Subject: Docket Nos. 50-361 and 50-362
ATWS Rule - TAC Nos. 59139/40
San Onofre Nuclear Generating Station
Units 2 and 3

SCE RESPONSE TO NRC QUESTIONS
ON DIVERSE TURBINE TRIP

Figure 2

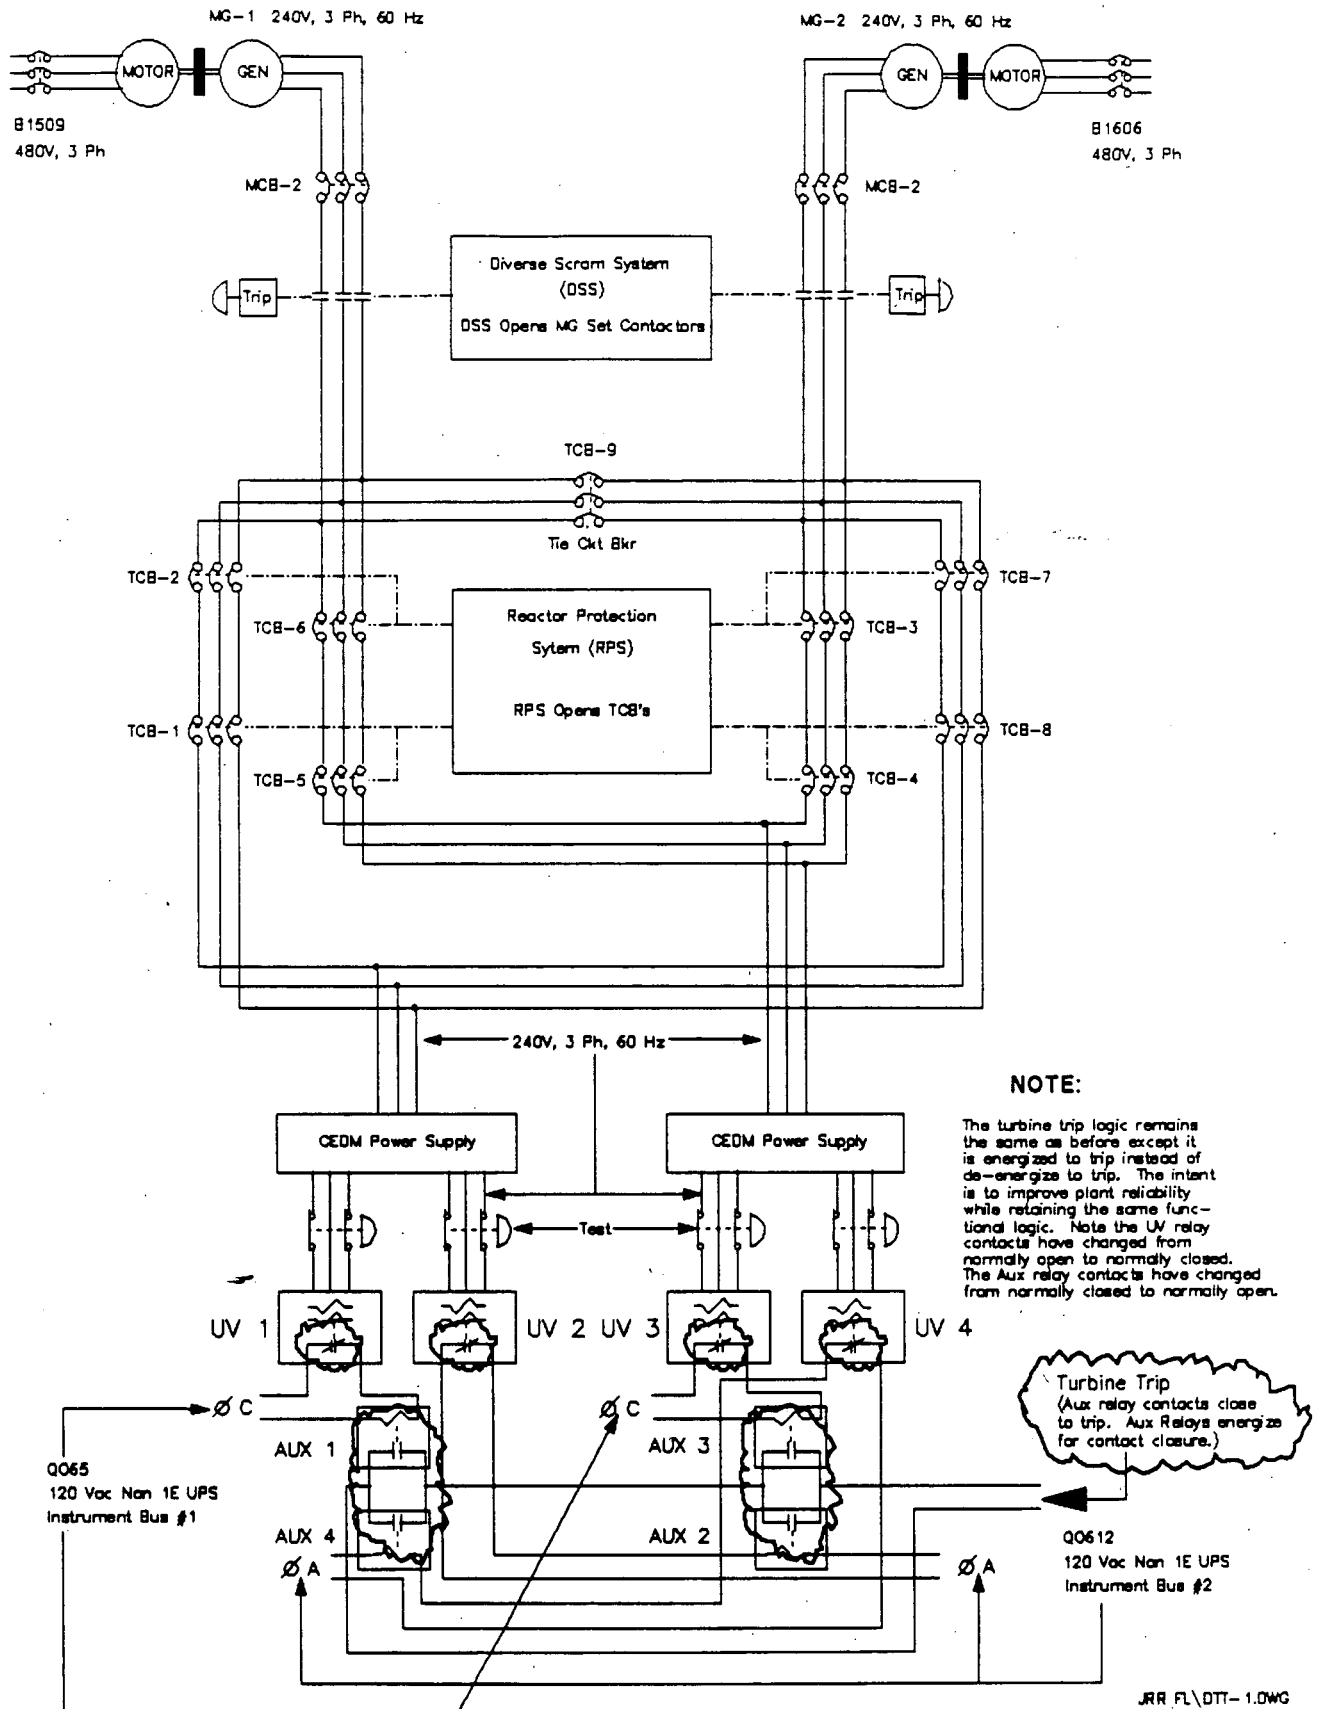
Please identify the type of power on the Diverse Turbine Trip (DTT) and provide a block diagram of the DTT.

At present, on loss of 240 Vac, the undervoltage relays de-energize and cause the auxiliary relays in a selective two out of four logic to de-energize and energize two turbine trip relays which initiate a turbine trip.

During the Cycle V refueling outages, the turbine trip function described above will be modified. The intent is to improve plant reliability while retaining the same functional logic. The existing trip logic will remain the same as

before except the auxiliary relays will be energized to trip instead of de-energize to trip.

Subsequent to Cycle V, on loss of 240 Vac, the undervoltage relays de-energize after a time delay energizing the auxiliary relays in a selective two out of four logic which in turn energizes the turbine trip relays (one out of two logic) to trip the turbine. The time delay on the undervoltage relays provides a means of discriminating between actual voltage loss and momentary transients. The auxiliary relays are powered from separate 120 Vac instruments buses derived from the Non-1E UPS.

Two simplified functional diagrams titled "Present Configuration" and "Proposed Configuration" are attached.
